MITIGATION PLAN

**Hip Bone Creek Restoration Site
Chatham County, North Carolina
DMS Project Number 100059
DMS Contract 7528
USACE AID #: SAW 2018-01160
DWR #: 2018-0785**

Subject: Hip Bone Creek Restoration Site
Mitigation Plan Review – Response to IRT Comments
Cape Fear River Basin - 03030003
Chatham County, North Carolina
DEQ Contract No. #7528
DMS Project #100059
USACE AID #: SAW-2018-01160

**FIGURE 1. PROJECT SITE VICINITY MAP
HIP BONE CREEK RESTORATION SITE
CHATHAM COUNTY, NC**

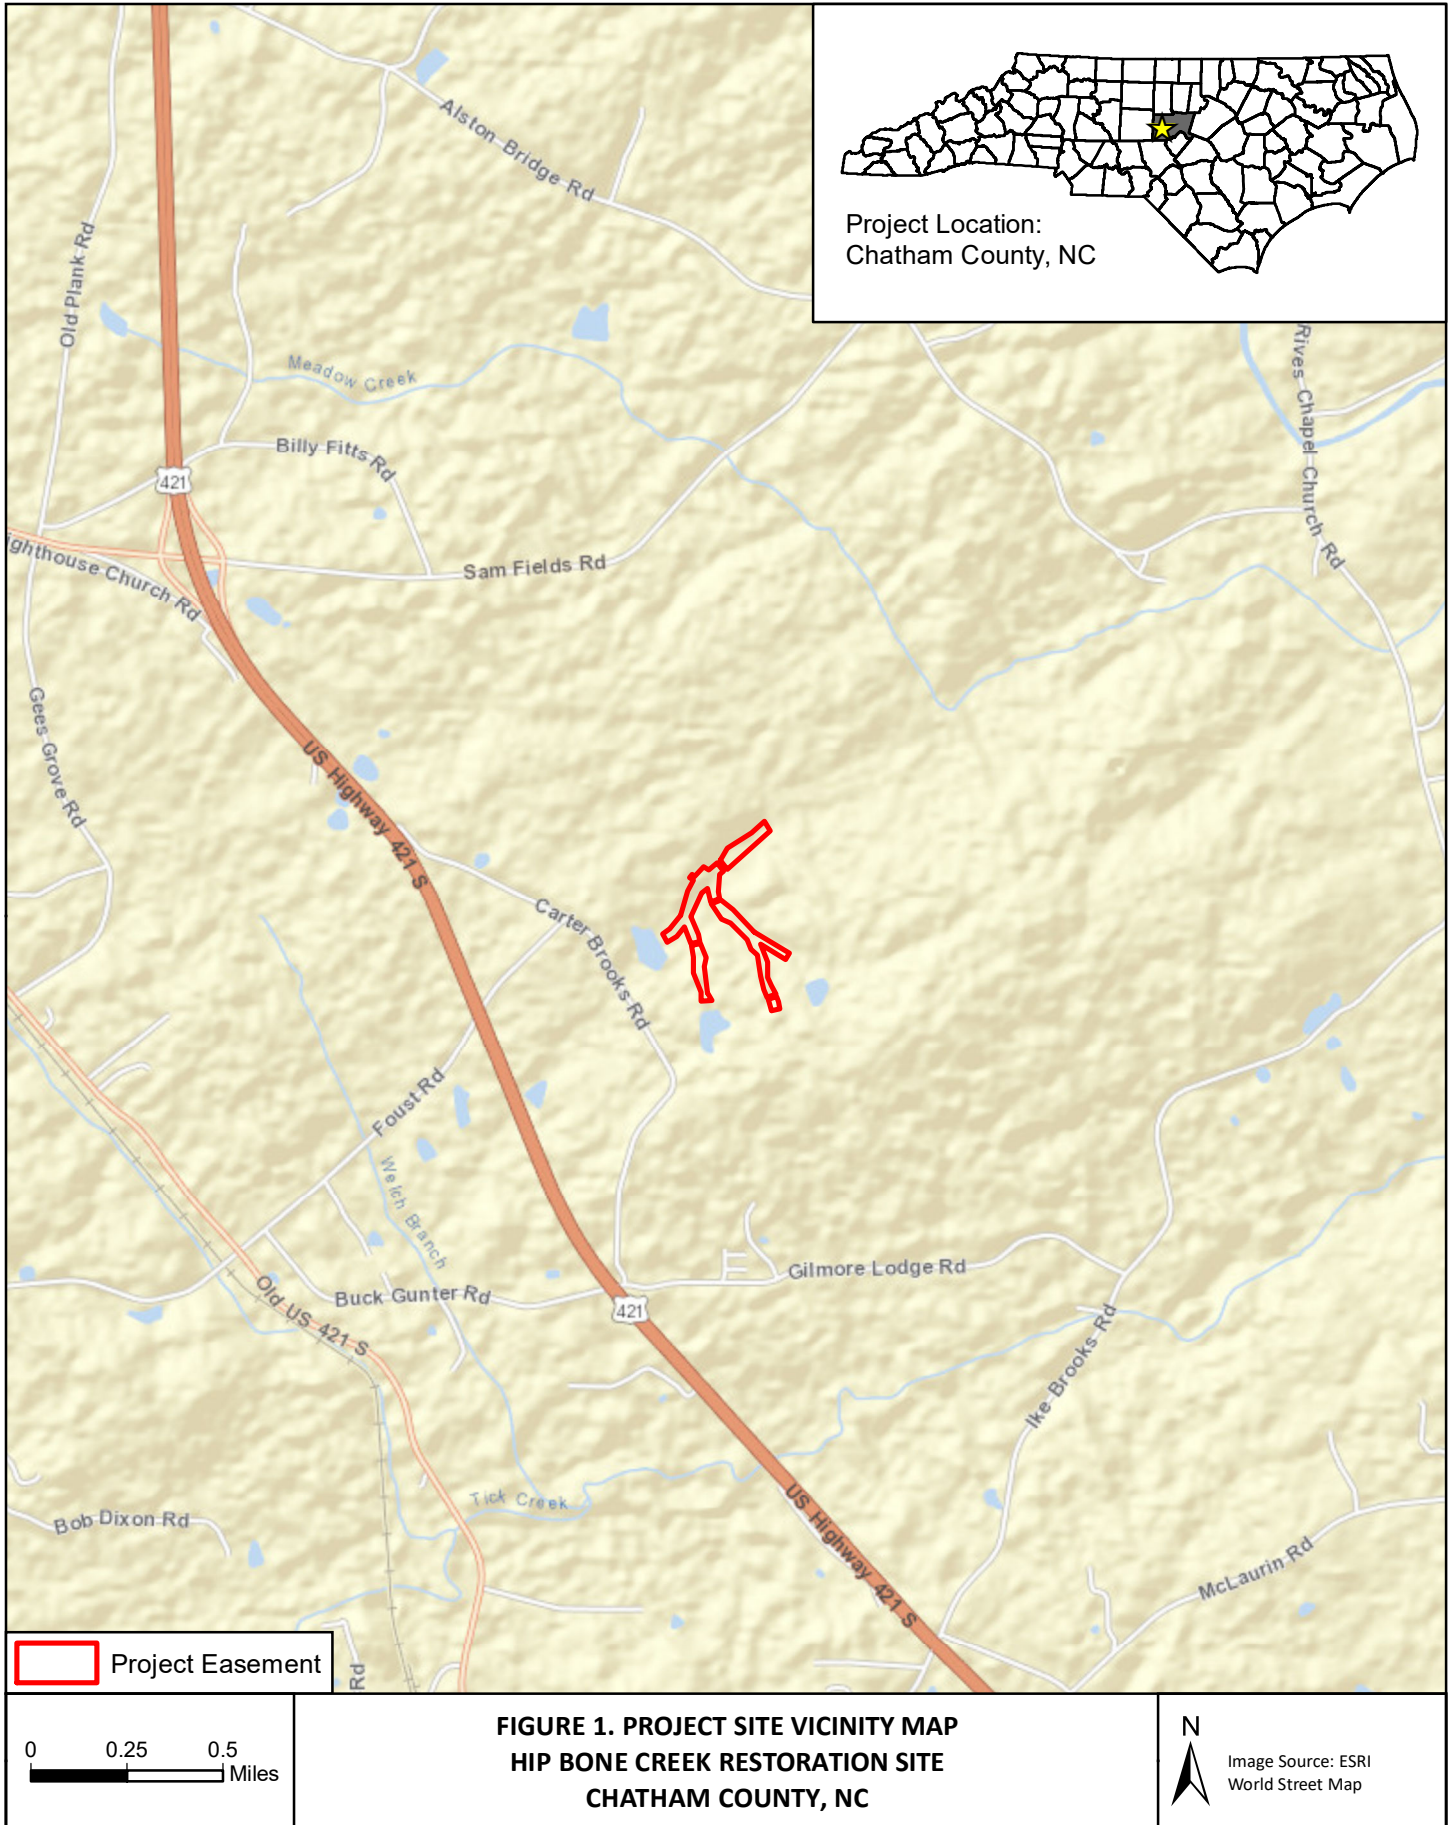
4. Figure 1 – site is not shown on figure.

**FIGURE 2. USGS TOPOGRAPHIC MAP
HIP BONE CREEK RESTORATION SITE
CHATHAM COUNTY, NC**

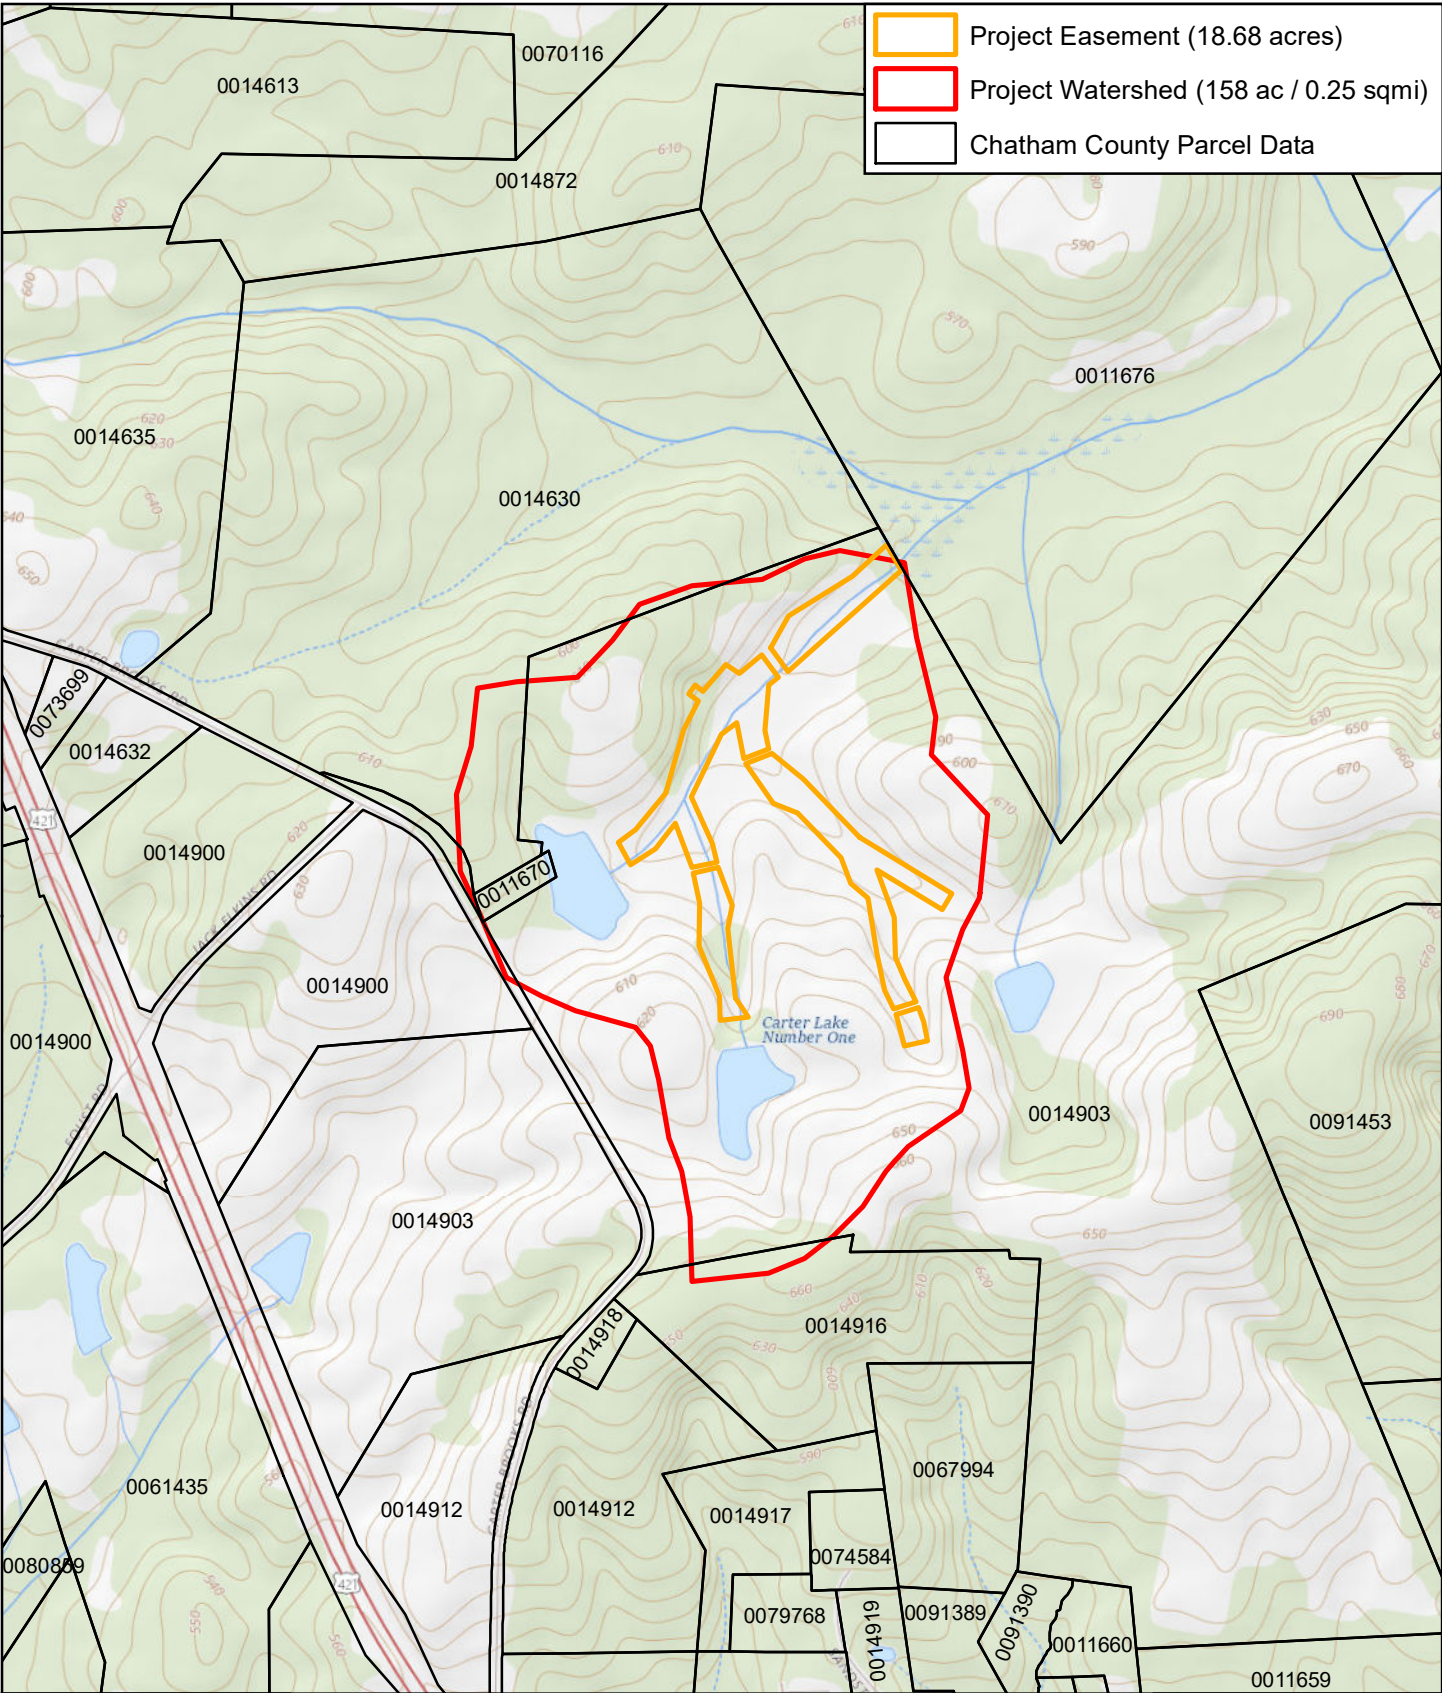
2. Page 8, Section 3.1.2
 - a. It would be helpful see property boundaries in the vicinity of the project. Could a tax parcel layer please be added to Figure 2 or a zoomed out Figure 5?

The Chatham County Parcel Data has been added to Figure 2.

FIGURE 5. PROJECT WATERSHED LAND USE
HIP BONE CREEK RESTORATION SITE
CHATHAM COUNTY, NC

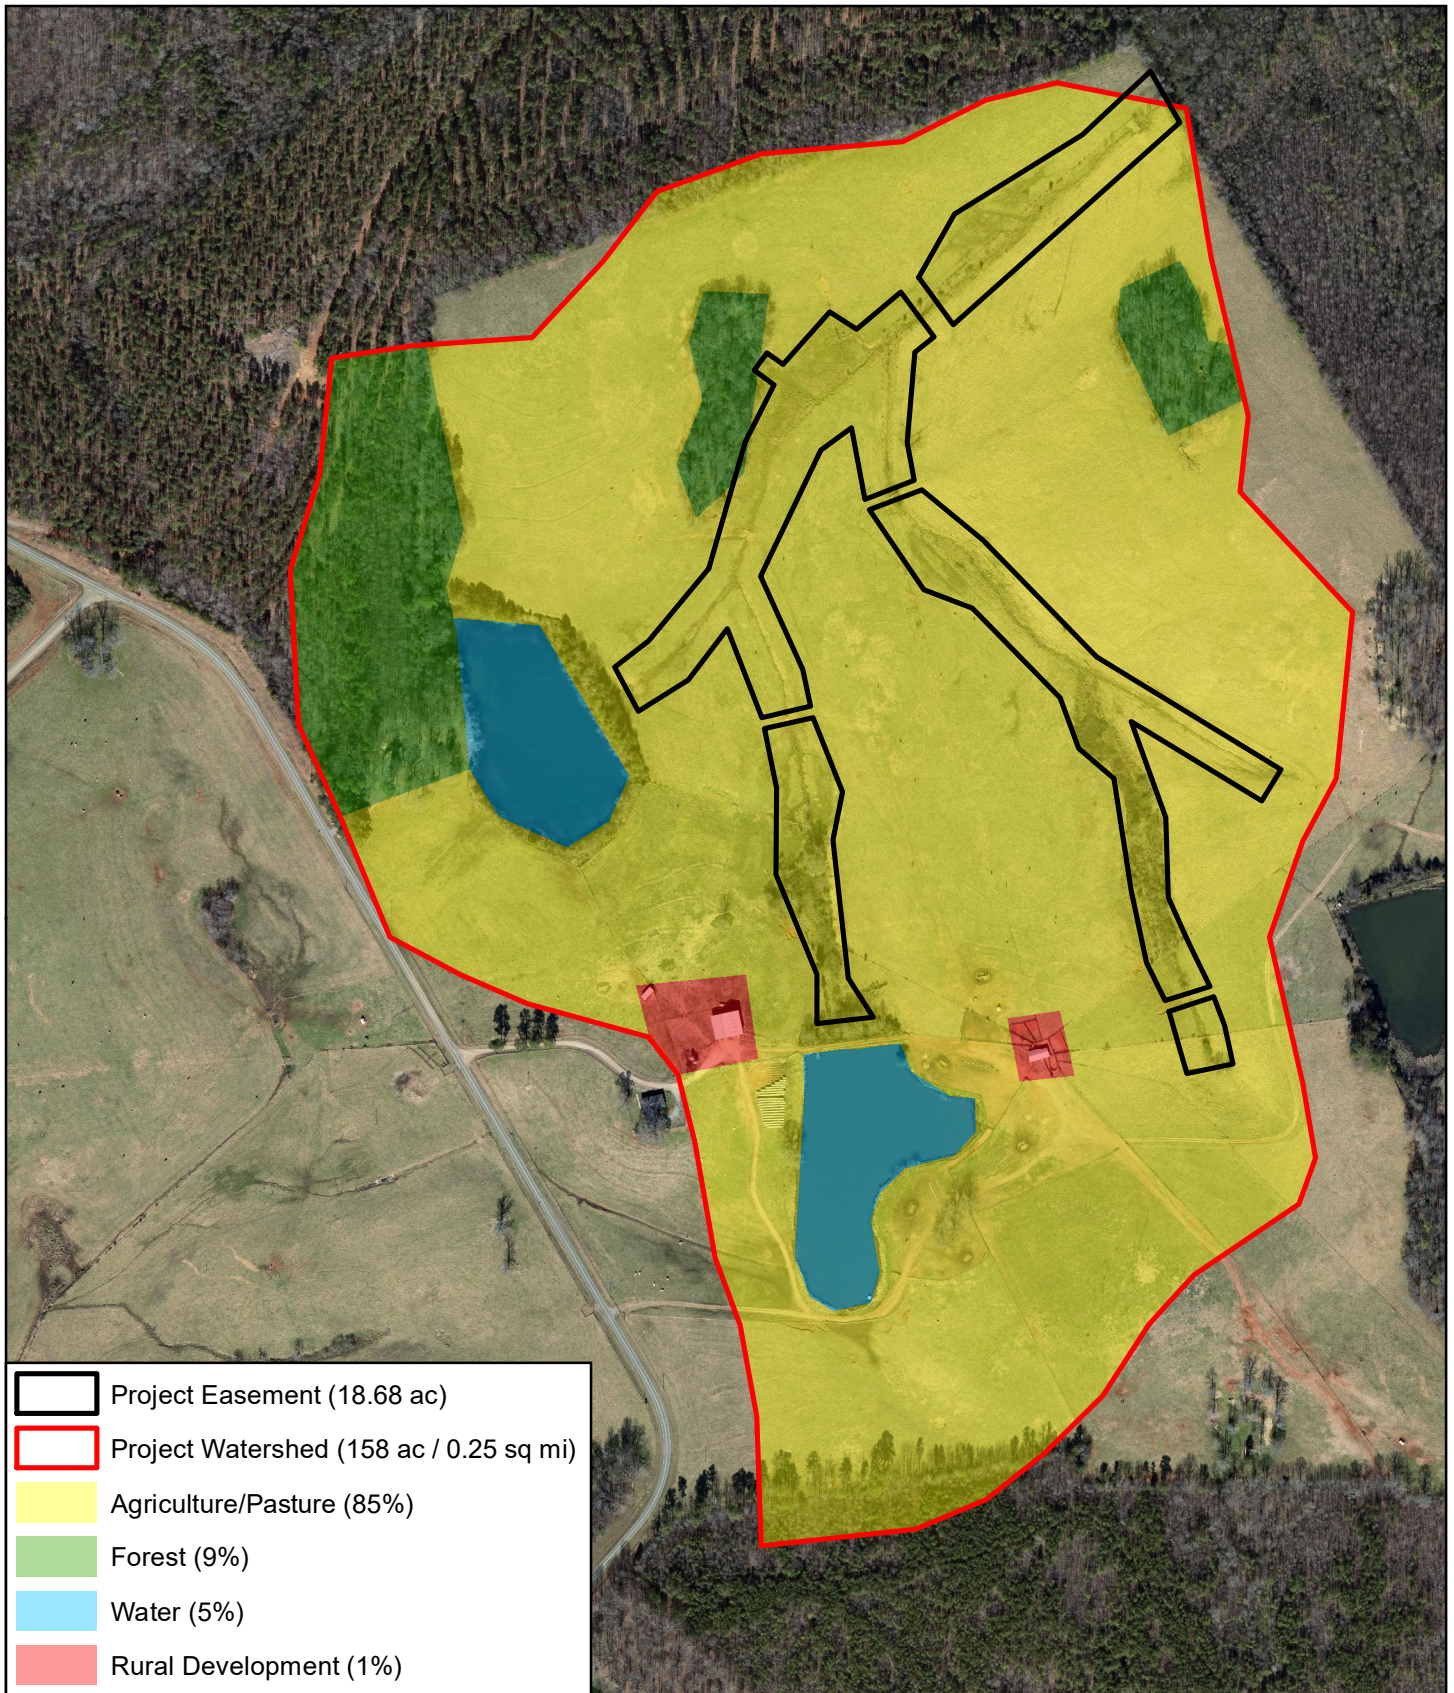
5. Section 3.1.2, page 8 – The first paragraph references Figure 4 and should reference Figure 5. The current land use breakdown of the project watershed totals 339 acres, but the project watershed is defined as 158 acres.

- b. Verify drainage areas for both T1 and T3. They add up to more than what was shown on Figure 5.

**FIGURE 8. PROJECT ASSET MAP
HIP BONE CREEK RESTORATION SITE
CHATHAM COUNTY, NC**

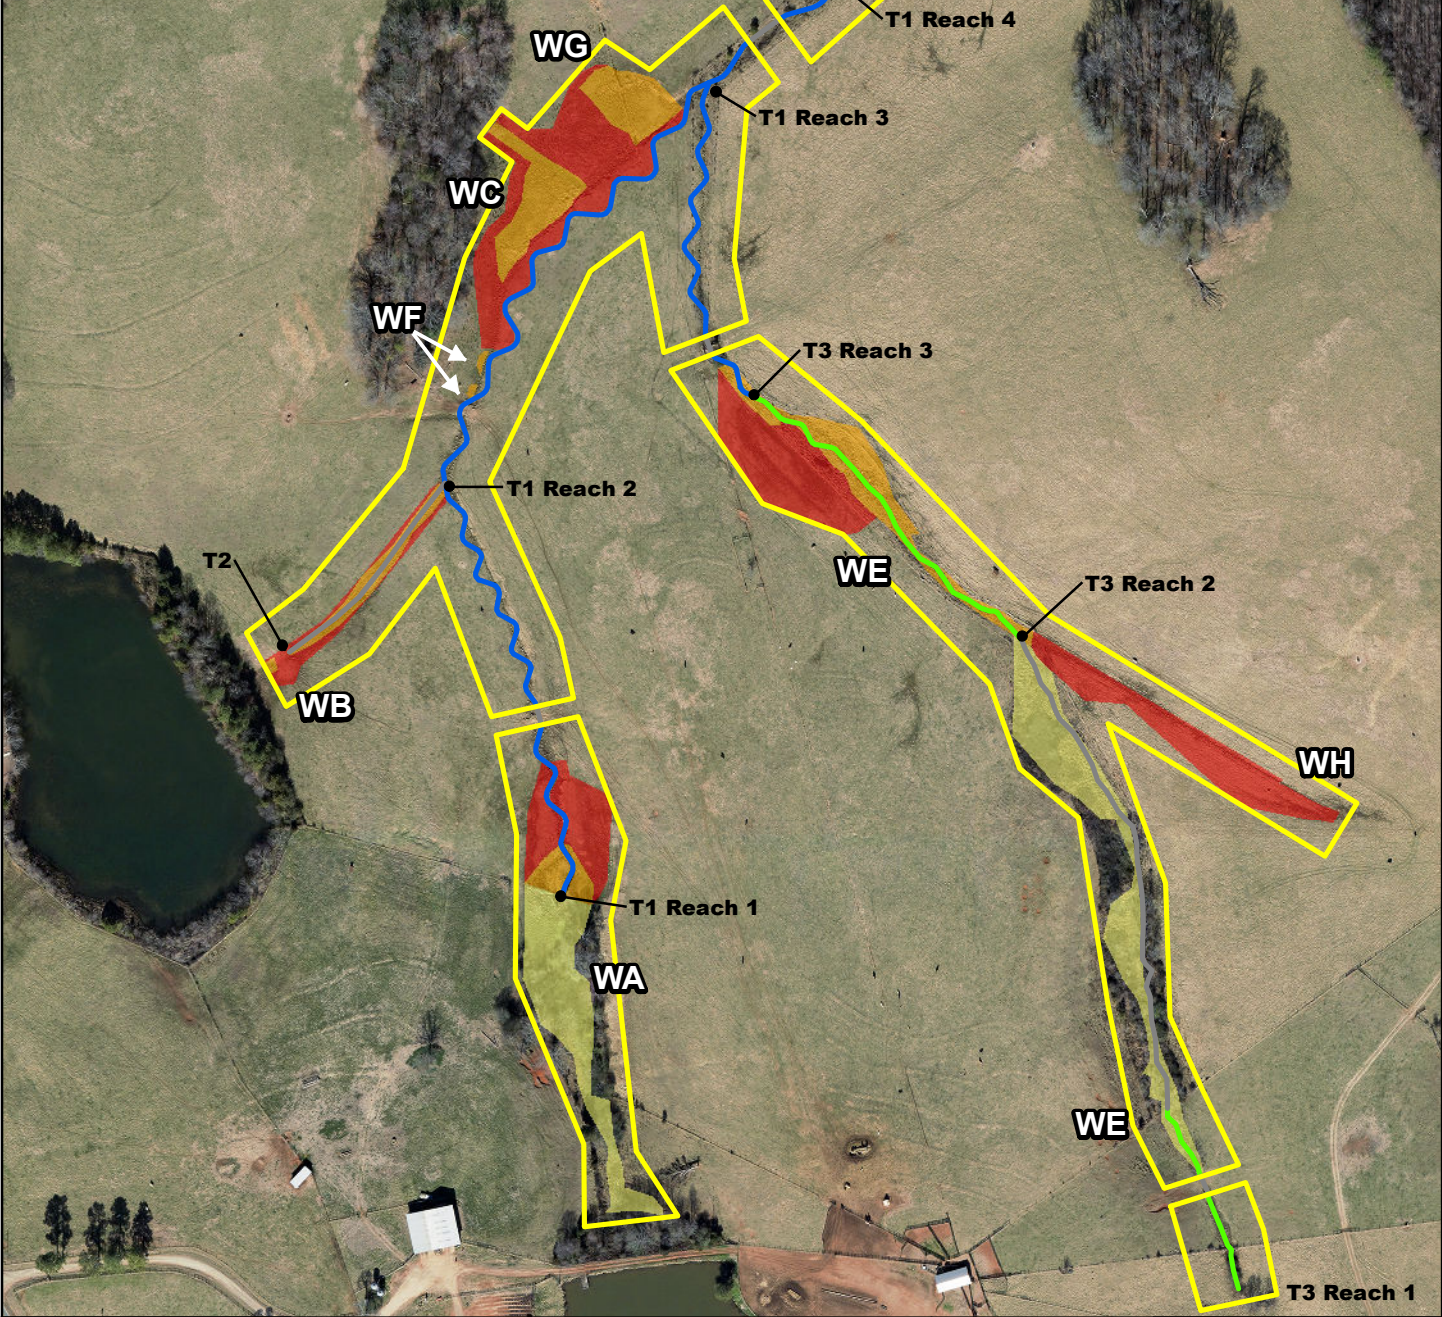
17. Figure 8
